SERVICE DIRECTIVE BULLETIN NO. T-003

1. SUBJECT: Possible Interference Involving Main Rotor Pitch Change Bellcrank (Cyclic Walking Beam), P/N 28-14207-101

2. MODEL: TH-28 and 480 Helicopters

FIGURE 1

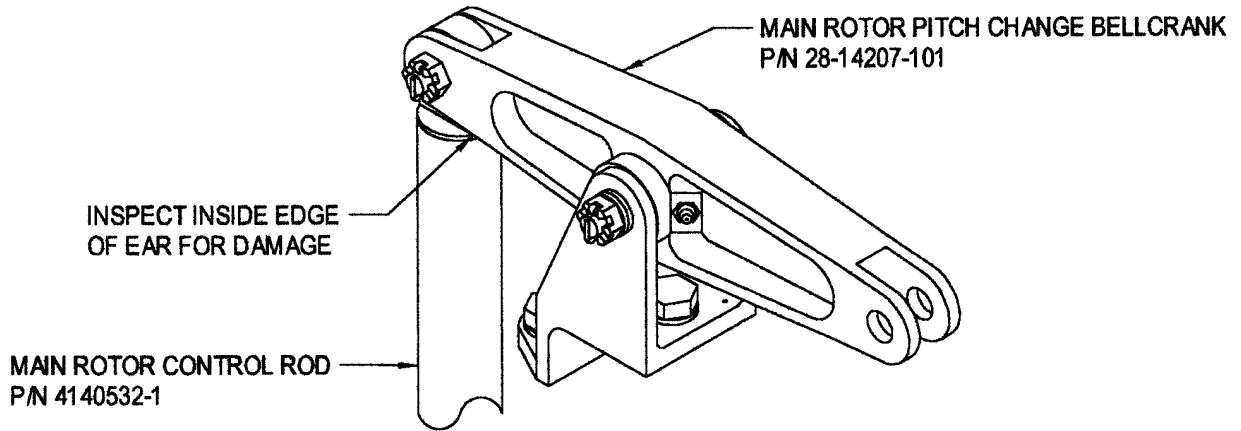
Within the next 5 hours time in service, visually inspect the ears of the Main Rotor Pitch Change Bellcranks, P/N 28-14207-101, for damage caused by contacting the end fitting in the Main Rotor Control Rods (See Figure 1). Inspect for damage by either moving the collective to the mid-range position and using a mirror to inspect for the damage or disconnect the Pitch Change Bellcranks from the Main Rotor Control Rods and the Bellcrank Bracket. Follow the procedures for collective friction use and removing the Pitch Change Bellcranks as found in the TH-28/480 Maintenance Manual.

If no damage is found, proceed to paragraph 5.1. If damage is found, remove the damaged Pitch Change Bellcrank(s) from the aircraft. Using a half-round "Swiss" file or other suitable device, remove the damage from the Pitch Change Bellcrank(s). After the damage is removed, polish the area with crocus cloth to a 32 finish or better and apply a protective coating of epoxy primer (Desoto #593 X 300 or equivalent). Modify the Main Rotor Control Rods following the procedure in paragraph 5.1.

FIGURE 2

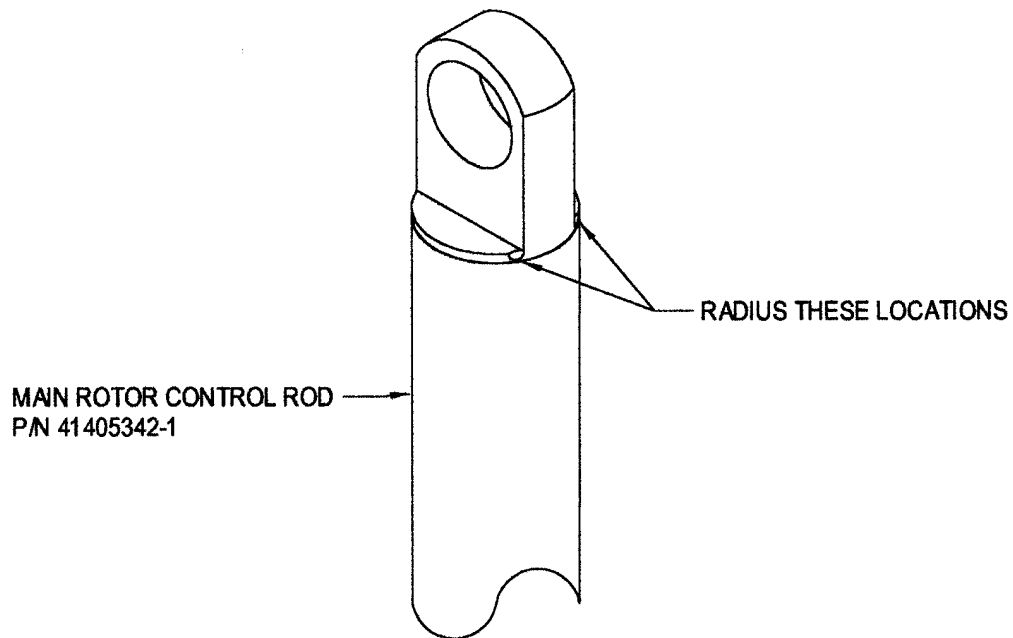
Using a $\frac{1}{8}$ (.125) inch round file or other suitable device, radius the edge of the end fitting in the Main Rotor Control Rod, P/N 4140532-1 (See Figure 2). After radiusing the edge of the end fitting, polish the area using crocus cloth to a 32 finish or better and apply a protective coating of epoxy primer (Desoto #593 X 300 or equivalent).
